Issue	**1**
Factory ID	**26310**
Date of Issue	**22-Apr-2026**

A A Garments

Structural Safety Inspection Report

Pakistan Accord Initial Safety Inspection Report

Figure 1.16. Main building: Typical beam framing layout plan

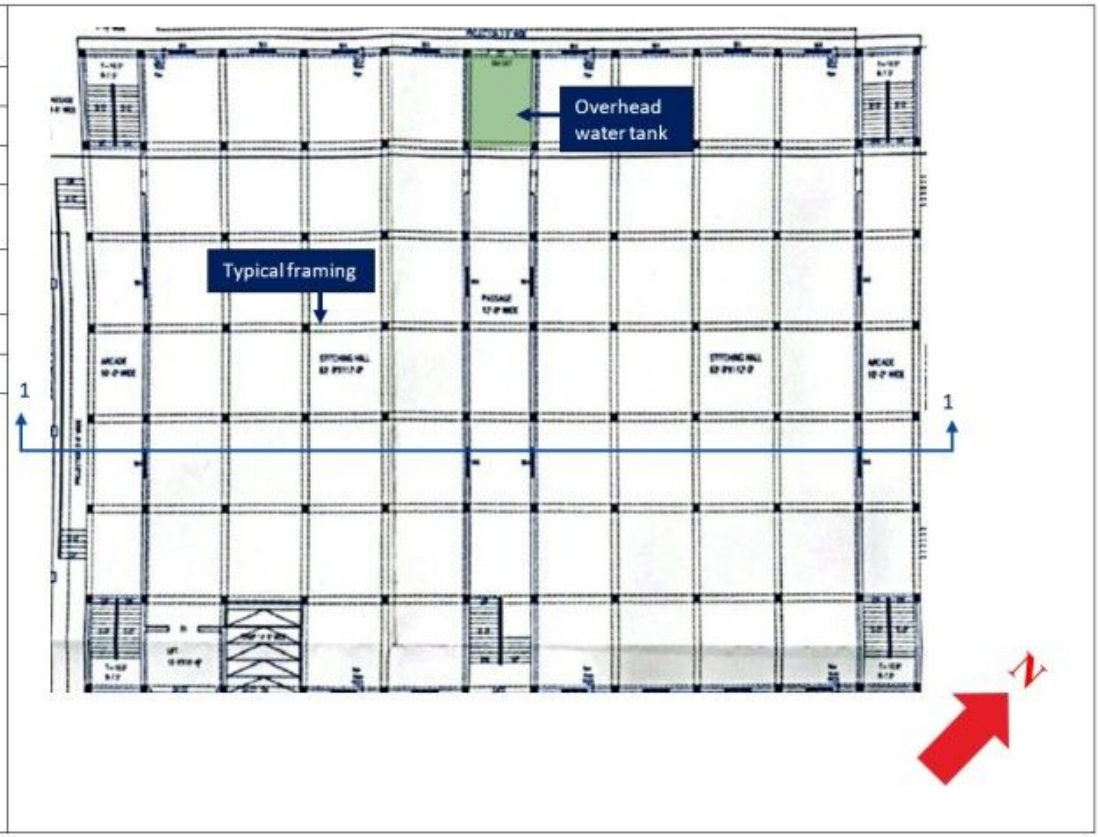
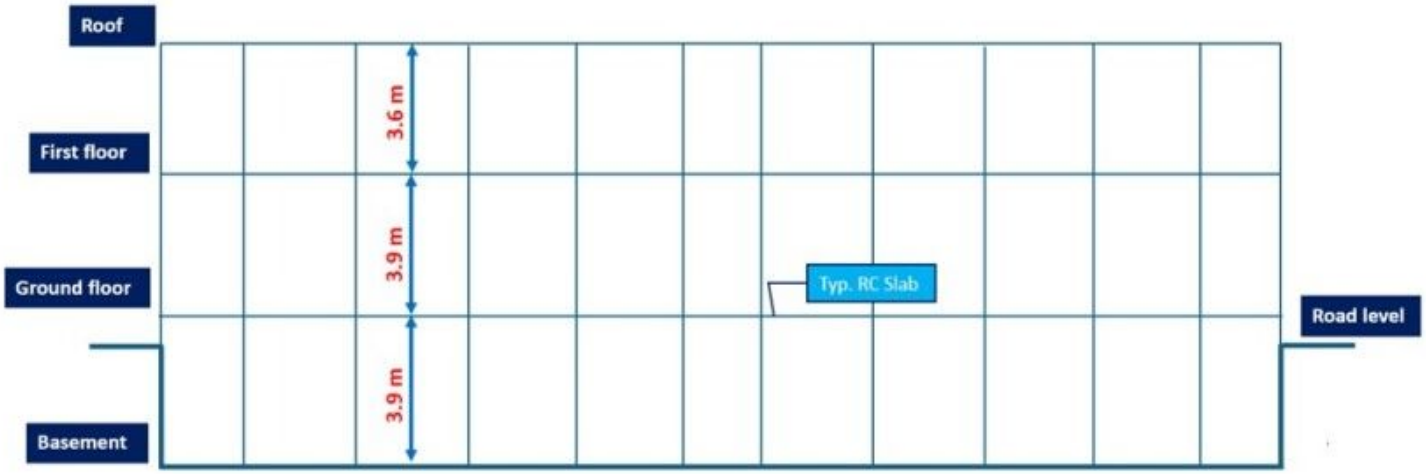
This issue pertains to the utility and canteen buildings, for which structural drawings are not available. Additionally, in the main building, discrepancies have been observed in the number of spans and grid dimensions. F-202604-064566

Timeline	Remediation Plan
Longer Term CAP-0076214	Building Structural Engineer to carry out on-site survey, collect information and produce accurate and complete as-built documentation.

Figure 2.1 - Office building: Plan showing location of the area at roof

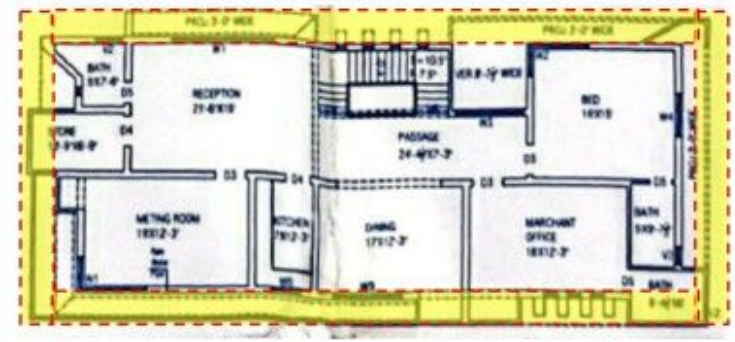
It concerns with inadequate edge protection which present a risk of potential injury resulting from slip, trip or fall from roof of office building where height of parapet wall is insufficient – Health & Safety concern F-202604-064563

Timeline	Remediation Plan
Immediate CAP-0076211	Provide adequate edge protection at roof, and on any other part of the factory with the same issue.
